**SERVICE INFORMATION LETTER**  
**Contains Useful Information Pertaining To Your Aircraft Engine**

**SIL10-6**  
 Technical Portions FAA  
 Approved

**SUBJECT: OIL COOLER AND VERNATHERM CONTROL VALVE FOR  
 CERTAIN ENGINES EXPERIENCING LOW OIL TEMPERATURES**

**MODELS AFFECTED:** IO-550-N, TSIO-550-C

Figure 1 Oil Cooler and Associated Parts

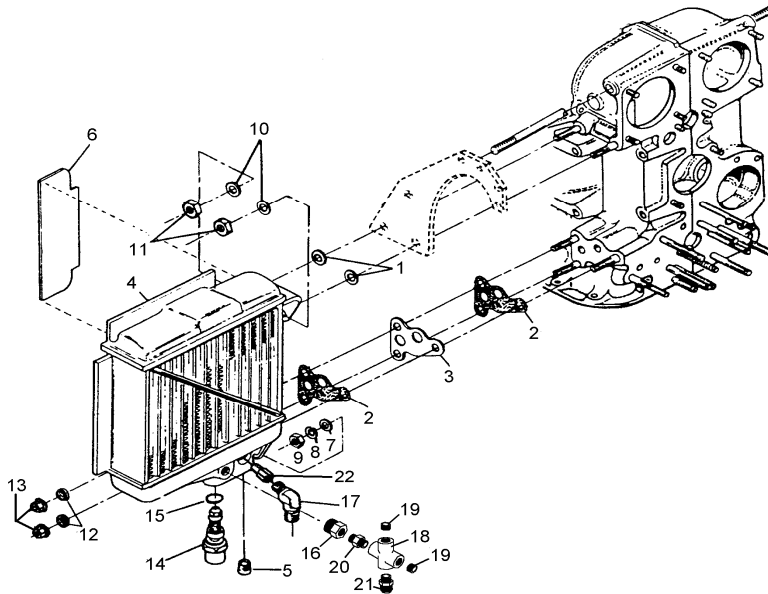
Cessna Corvalis 300, 350 engines that exhibit low oil temperatures (below 160 degrees F in normal operation) are eligible for installation of a replacement vernatherm control valve which will provide improved operational characteristics in cold climates and higher flight altitudes.

Cessna Corvalis 400 engines that exhibit low oil temperatures (below 160 degrees F in normal operation) are eligible for installation of a replacement engine oil cooler and vernatherm control valve which provide improved operational characteristics in cold climates and higher flight altitudes.

**Removal and installation of the vernatherm control valve Corvalis 300, 350 (See Figure 1)**

1. Locate and remove the vernatherm control valve and gasket (14, 15)
2. Install the new vernatherm control valve and gasket utilizing current revision of SB96-7 for correct torque.
3. After installation, run engine for leak check, correct any leaks found during test run and reinstall cowling in accordance with Cessna maintenance instructions.
4. Conduct a test flight to confirm oil temperature in operation. This test flight should allow the engine to reach normal operating temperatures (approximately 30 minutes flight time) prior to notation of any oil temperatures. **Note:** If aircraft is equipped with oil cooler winterization door that restricts cooling air flow through the oil cooler, note temperatures both open and closed.

**Removal and Installation of the oil cooler and Vernatherm valve Corvalis 400 (See Figure 1)**

1. Remove cowling following Cessna maintenance instructions.
2. Remove baffling and induction system components as required.
3. Remove the flanged nuts (Figure 12-18 in TCM Maintenance Manual M-18 and Figure 1 following) (13) and lock washers (12) from the lower front crankcase studs. Discard the lock washers (12). Remove the oil cooler (3) from the crankcase studs.

4. Remove the nut (9) lock washer (8) and washer (7) from the lower rear studs. Discard the lock washer (8).
5. Remove the nut (11) washer (10) and gaskets (1) from the upper studs.

6. Remove the oil cooler (4) from the crankcase.
7. Remove the bracket (shadowed) from the crankcase studs.
8. Remove the gaskets (2), spacer (3), and baffle (6).

9. Discard the gaskets and spacer (2), (3).
10. Remove the reducer (16), elbow (17), tee (18), cap (19), fitting (20), and adapter (21).
11. Remove the vernatherm control valve (14) and gasket (15)

- 1 ea 657496 Vernatherm control valve (new gasket furnished with valve)

- 1 ea 654585 Oil Cooler Assembly
- 1 ea 657496 Vernatherm control valve (new gasket furnished with valve)
- 2 ea 649989 Oil Cooler Gasket
- 2 ea 649961 Gasket, Washer
- 1 ea 640342 Spacer

12. Install the replacement oil cooler, vernatherm control valve and gasket in reverse order of removal. Utilize current revision of SB96-7 for correct torque. Lube all fasteners with 50w oil prior to applying torque as described in the service bulletin.
